1 **Response to reviewer 1: ‘Automated ArcticDEM iceberg detection tool:**
2 **insights into area and volume distributions, and their potential application to**
3 **satellite imagery and modelling of glacier-iceberg-ocean systems’ by Shiggins**
4 **et al.**

100 *Draft figure 1. Google Earth Engine ArcticDEM v3 strip data availability (July-*
101 *October) for Greenland’s calving margins (Goliber et al., 2022) and the extent of all*
102 *marine/lake/shelf terminating glaciers extent in the remainder of the Arctic (RGI v6;*
103 *Pfeffer et al., 2014).*

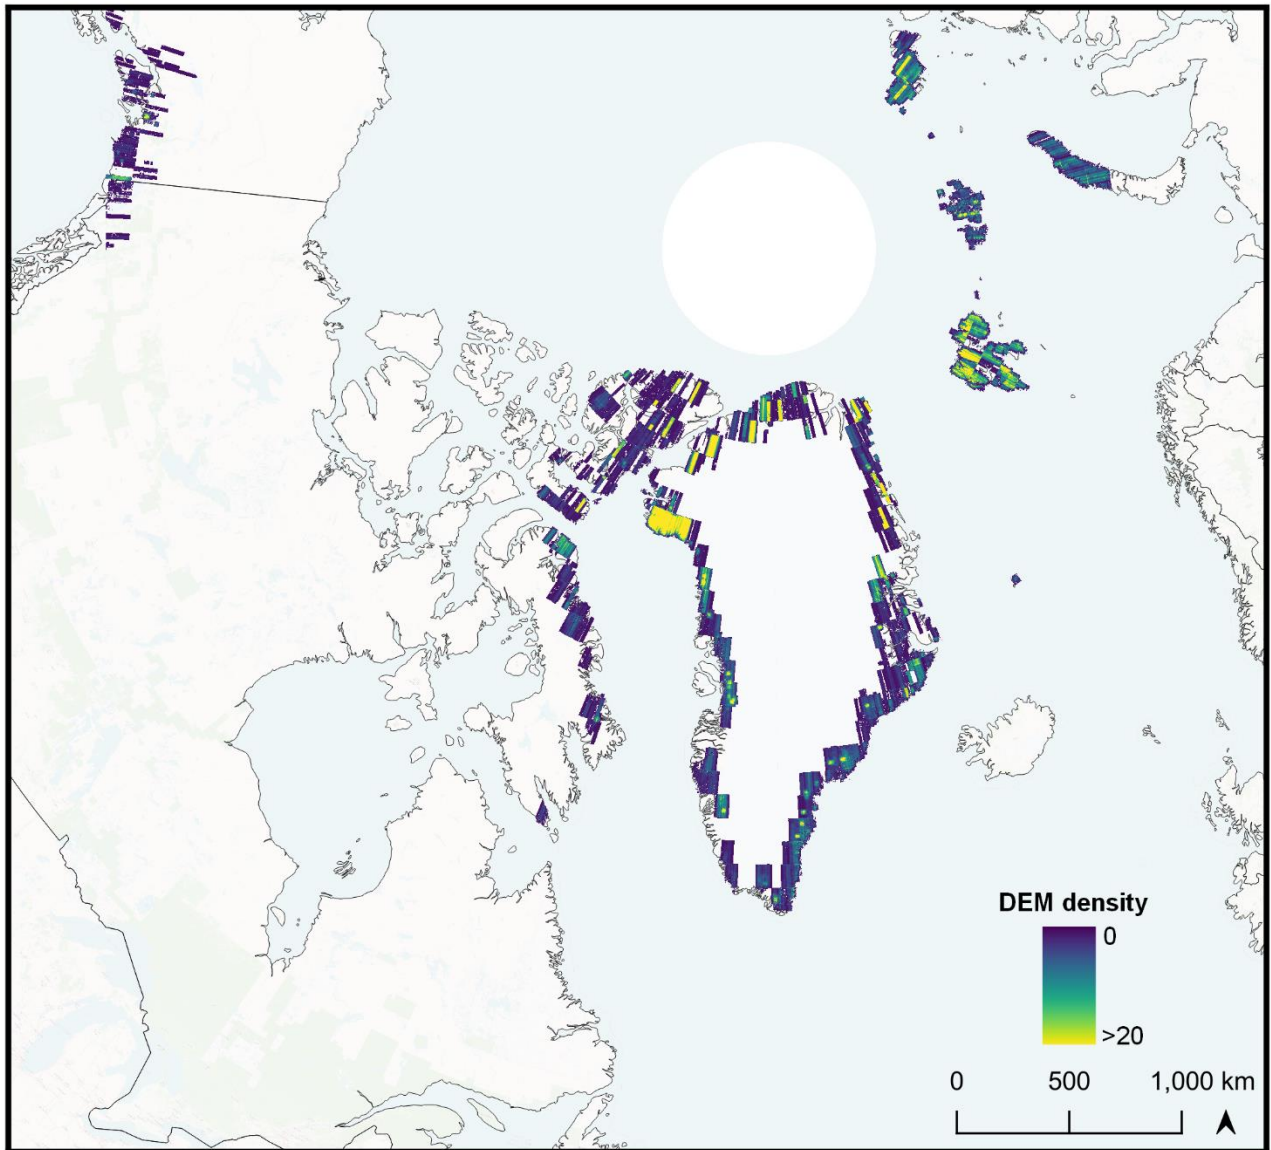
54 2. The authors make a couple of references to this method having the potential
55 to be upscaled across the full continent. However, they also suggest that
56 there would need to be good enough data coverage for this. Please can the
57 authors clarify whether there is enough data for pan-Arctic application or not?

- 58 • We have created a draft supplementary figure (see Draft Figure 1
59 below) which shows the coverage of ArcticDEM strip data on the pan-
60 Arctic scale using locations identified as marine terminating glaciers for
61 non-ice sheet and ice sheet glaciers (from the Randolph Glacier
62 Inventory (RGI) v6 and Goliber et al. (2022) respectively). The map has
63 been created by identifying the footprints of ArcticDEM strip data where
64 there is overlap within 5 km of the point locations provided by Goliber
65 et al. (2022) for Greenland, and having any overlap with RGI glacier
66 outlines whose metadata show them as being either lake terminating,
67 marine terminating or shelf terminating. This figure will be included as
68 supplementary data in the revised manuscript. However, as RGI data
69 use a benchmark of glacier outlines observed at near to 2000 as
70 possible and some glaciers have now retreated into proglacial lakes

71 (e.g. in Iceland) or changed their terminal environments, this map may
72 not include ArcticDEM coverage of these glaciers. Consequently, we
73 have also created summary maps showing all ArcticDEM data
74 coverage irrespective of whether they cover glaciers or not.

- 75 • To allow users to get a quick impression of data availability for a given
76 ROI we have now included new functionality within the GUI to view a
77 series of summary maps showing ArcticDEM coverage. This includes:

- 78 1. Map showing July-October coverage for known calving glaciers
79 (Draft Figure 1; i.e. data least likely to be affected by solid
80 melange/sea ice).

- 81 2. Map showing all ArcticDEM coverage for known calving glaciers
82 irrespective of acquisition time.
 - 83 3. Map showing all ArcticDEM coverage from the entire dataset
84 irrespective of whether a glacier is thought to be there or not.

- 85 4. As map 3, but for the months July-October.
- 86 • Further functionality to allow users to filter DEMs by month of
87 acquisition has also been added to the GUI. The analysis workflow for
88 this revised GUI has otherwise not been changed. The revised GUI for
89 inclusion can be accessed at the following link:
90 ([https://code.earthengine.google.com/ad11c00c37b7ad88e28c4493ee
91 6eec64](https://code.earthengine.google.com/ad11c00c37b7ad88e28c4493ee6eec64)).

- 92 • It is worth noting that these maps show where ArcticDEM data are
93 available irrespective of the quality of the DEM data. Consequently,
94 they do not indicate that all of the DEMs will be of sufficient
95 quality/coverage to allow it to be used for analysis.

112 *Draft figure 2. New location maps for the study sites with changed imagery*
113 *(ArcticDEM from Sentinel-2) and ROI outlines in black.*

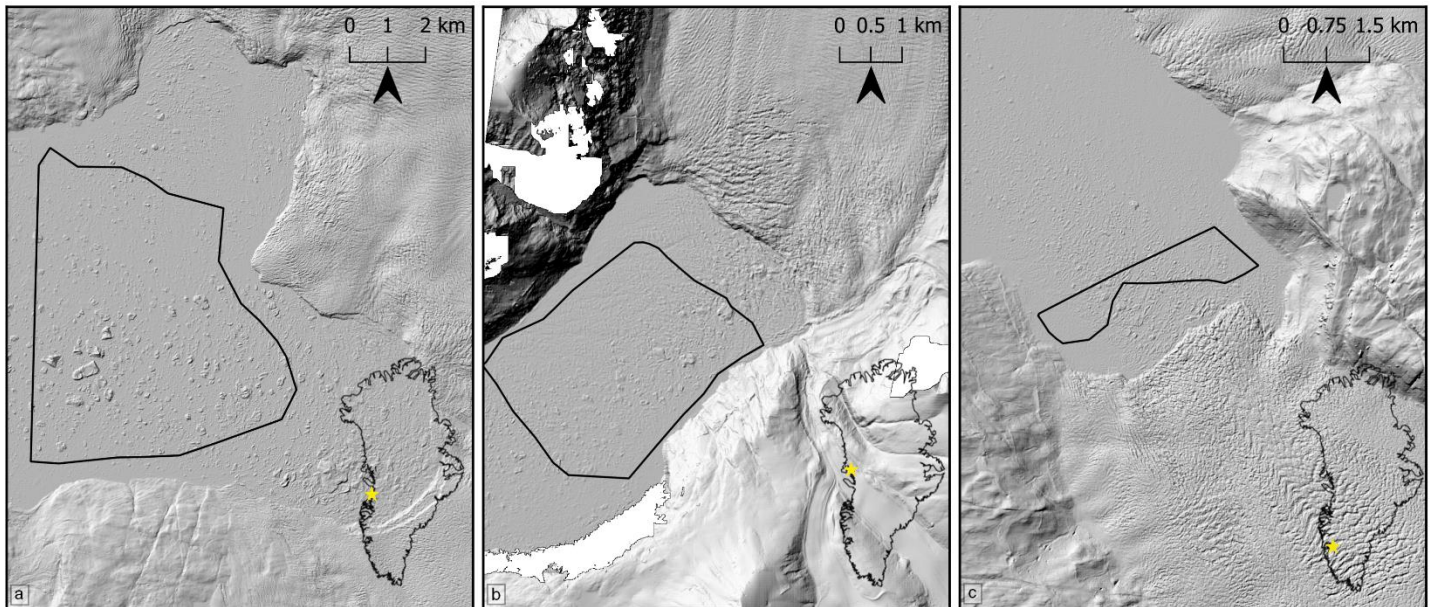
- 104 3. It would be good to see some figures showing what the DEM data looks like.
105 You may have readers who have not worked with the Arctic DEM before, and
106 it makes your workflow hard to understand without seeing some
107 visualisations. Please can the authors add a figure (or two) where they deem
108 it most appropriate.

213 13. (L129): Tidy up these figures where possible. The 'a' 'b' 'c' labels, north arrows,
214 and scale bars would be better on a white background rather than a translucent
215 background. Could you also make all the ROI outlines either green or red?

219 14. (L133): I would say this bounding box is green? Comment on the subset map
220 also.

109 We will replace our figure location maps that used Sentinel-2 imagery with hillshaded
110 ArcticDEM data to provide readers with an indication as to what the DEM data look
111 like. See below for the new draft location figure to replace Figure 1.

- 216 • Draft Figure 2 has been created in response to main comment 3 (RL04). This
217 has been changed to show examples of ArcticDEM imagery and the ROI
218 outlines have been changed to black for colour accessibility and consistency.

- 221 • Colour will be changed to black. See Draft Figure 2.
